Access Compliance Report Public Rights-of-Way (Curb Ramps)

Main Street: ESENCIA_DR		Cross Street: MEDANO_ST		Location:	W
ADA ID: RPRK211130131959	Ramp Type:Type 1 - Perpendicular	Initial Pass/Fail: Pass	Overall Compliance: No	Severity Score:	0

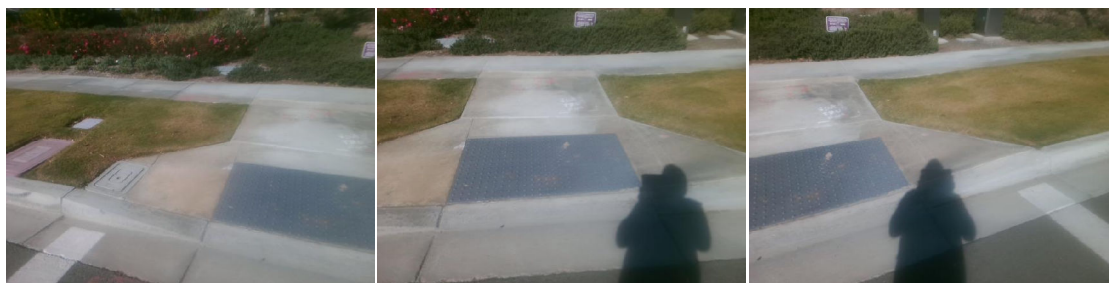
Codes/Mitigation Info/Possible Solution		Field Measurements/Component Compliance	
---	--	---	--

Remove & Replace Entire Ramp. Restripe Crosswalk. Remove & Replace Gutter. Utility Present.

R304.2.2, R304.5.3, R207.1, STD 1115
